**ASHLAND PLANNING COMMISSION
REGULAR MEETING
APRIL 8, 2008
AGENDA**

**CITY OF
ASHLAND**
ASHLAND PLANNING COMMISSION
REGULAR MEETING
MARCH 11, 2008
MINUTES

PLANNING ACTION: 2008-00182

ASHLAND PLANNING DEPARTMENT STAFF REPORT ADDENDUM

Figure 1: Lithia Way at Second St. Redevelopment under Existing Arterial Setback Requirements

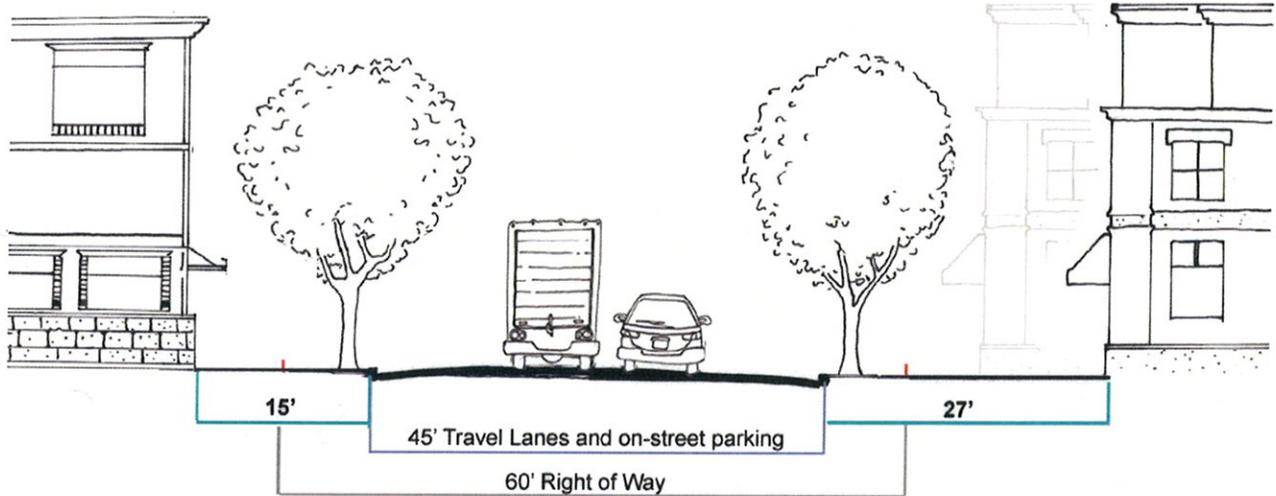
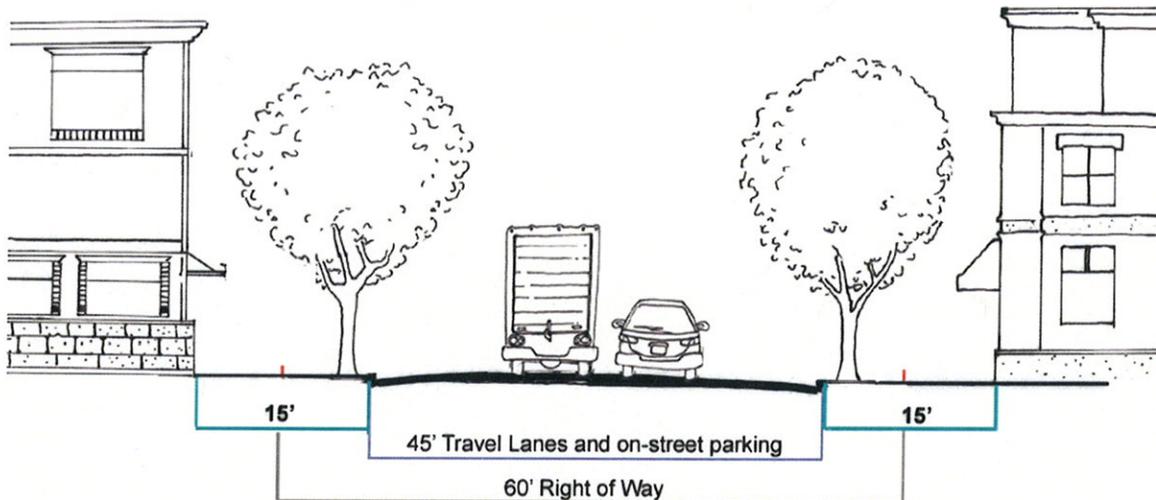
The proposed amendment to the Special Setback Requirements expands the exception from the 20-foot front yard requirement for properties abutting arterial streets to include

all properties abutting Lithia Way. As a result, buildings on both sides of the street could be located up to the private property side of the sidewalk. The street cross sections below are examples of what redevelopment of the parking lot and old Rocket Photo Building at Lithia Way and Second Street would look like under the existing arterial setback requirement, and under the proposed amendment.

Figure 2: Lithia Way at Second St. Redevelopment under Proposed Arterial Setback Revision
